**SUSQUEHANNA STEAM ELECTRIC STATION
RESPONSE TO REQUEST FOR ADDITIONAL INFORMATION
REGARDING CHANGES TO TECHNICAL SPECIFICATION (TS)
SURVEILLANCE REQUIREMENT (SR) 3.8.1.19 TO
INCREASE DIESEL GENERATOR E MINIMUM
STEADY STATE FREQUENCY
PLA-6998**

**Docket Nos. 50-387
and 50-388**

Response to NRC Request for Additional Information

**Calculation EC-024-1014 Justification for ITS Diesel
Generator Frequency Acceptance
Limits of 60 +/- 1.2 Hz**

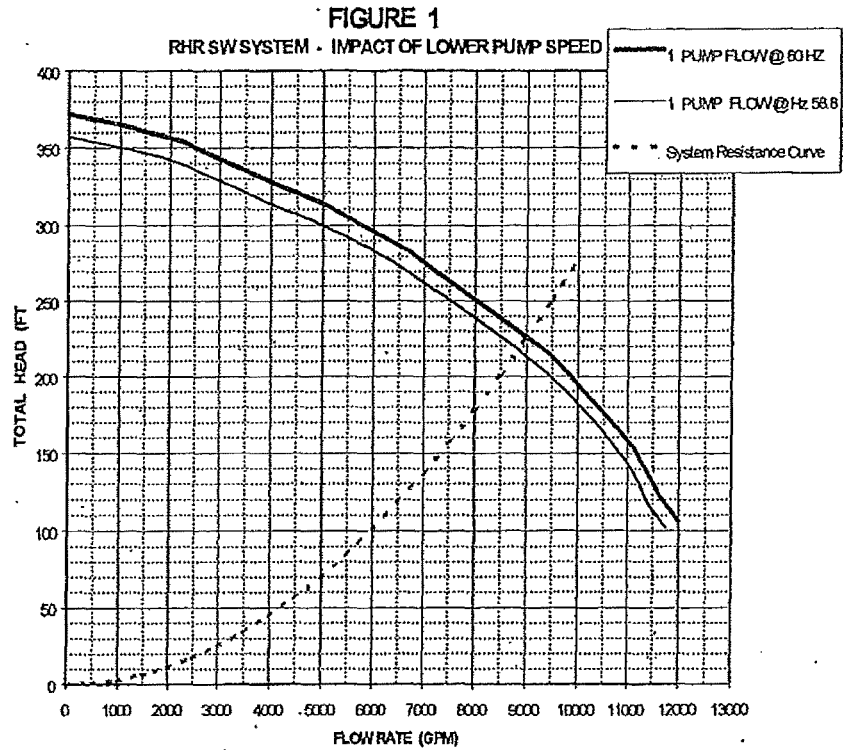
In Figure 1, the pump curve for a typical SSES RHR SW pump is plotted.⁽⁵⁾ The pump affinity laws were used to calculate a "degraded" curve corresponding to a pump speed of 58.8 Hz which is also plotted. Finally, a system resistance curve, which corresponds to a flow of 9000 GPM at 100% pump speed, is identified. Note that this system resistance curve would be established by operators via the throttling of the RHRSW heat exchanger inlet valve in accordance with operating procedures.⁽⁶⁾ If pump performance were to decrease because of a lower speed, the RHR SW flow through the heat exchanger would decrease to the point where the system resistance curve intersects the degraded curve. By inspection, it is seen that this flow is approximately 8750 GPM. This flow is well in excess of the minimum required RHR SW flow of 8000 GPM, as identified in Reference 7. Therefore, a 2% reduction in pump speed will not adversely affect post accident RHR SW cooling flow.

FIGURE 2
ESWSYSTEM - IMPACT OF LOWER PUMP SPEED

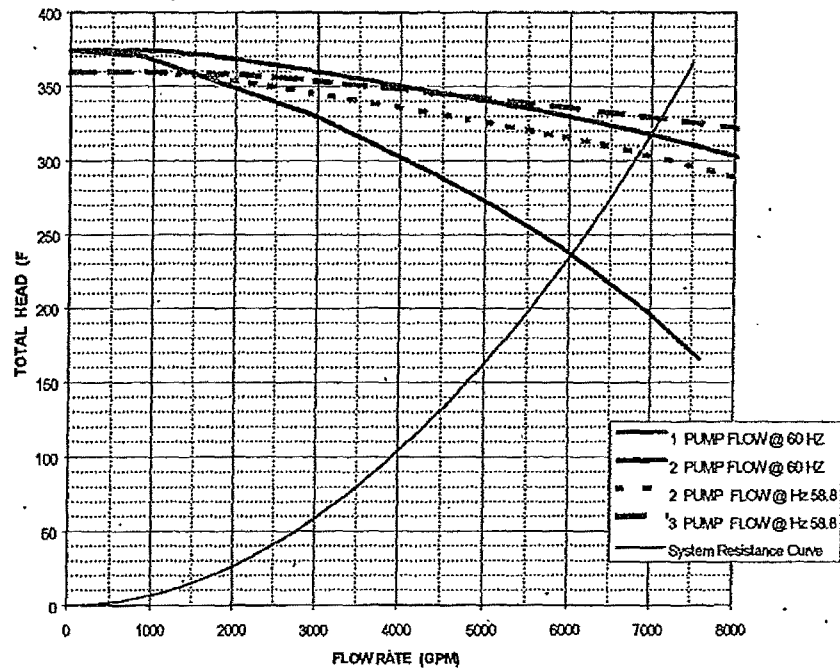
In Figure 2, the pump curve for a typical SSES ESW pump is plotted.⁽¹²⁾ Also plotted is the equivalent curve for two pump operation in parallel, as well as a conservative system resistance curve which intersects the two pump curve at a flow of 7000 GPM. This flow was selected because it bounds the flow requirements of a single loop of ESW.⁽⁸⁾ Finally, a "degraded" curve is plotted which corresponds to three pumps operating with a 2% reduction in speed (58.8 Hz). By inspection, it is seen that 7000 GPM, the "degraded" three-pump curve is above the "normal" two pump curve, which is known to provide adequate flow to the associated users.⁽¹¹⁾ Therefore, as long as three ESW pumps are available, they would be able to provide adequate flow and head even when operated with a 2% reduction in speed.
